SB-10043466-4051

Title:
MaxxForce 11 and 13 – Special Fuel Rail Kit

Applies To:
 Specific Serial numbers within the range 125HM2Y4100013 and 125HM2Y4101731, see attached for further clarification
 Vehicle – Models, MY2010 – includes – excludes - engines and features.
 Built From 7/21/2010 To 8/15/2010

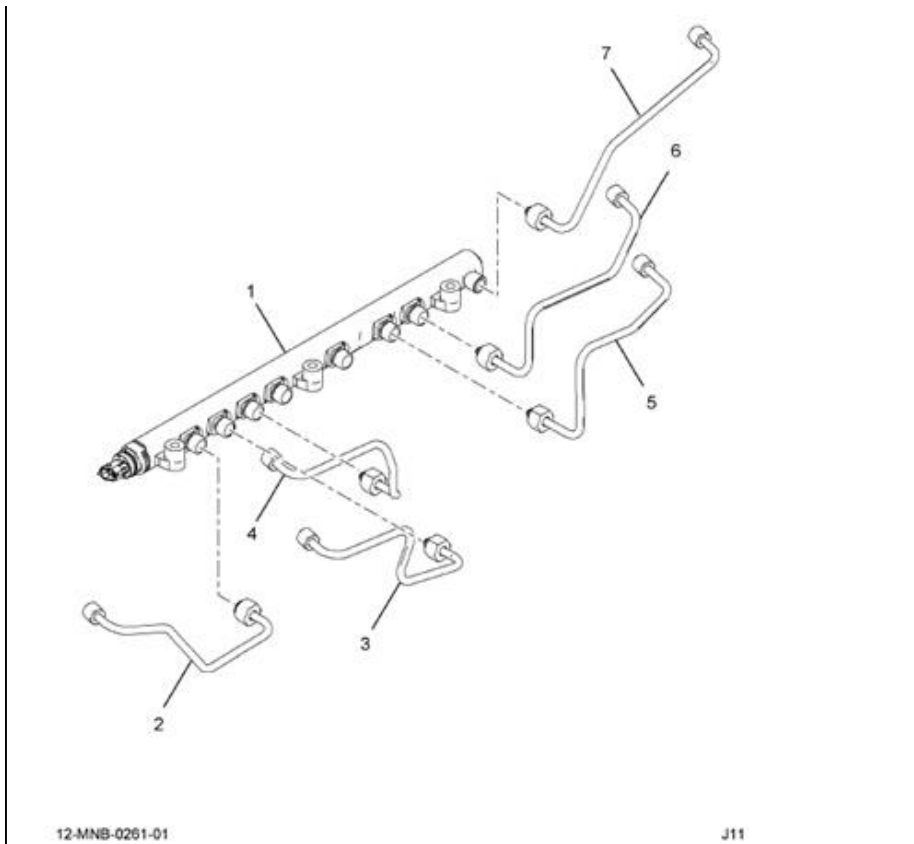
Engines with serial number listed below were build with Fuel to Rail tubes that are excessively hard. During initial installation, these tubes may distort the fuel rail making a replacement fuel to rail tube not seat properly.
 When replacing any fuel to rail tubes (items 2 - 7) on one of the affected vehicles (listed below), the following kit should be used, 3014634C91.
 Subsequent repairs to tubes or rails should be done as directed in the service manual.

3014634C91 FUEL RAIL AND TUBE KIT, SPECIAL
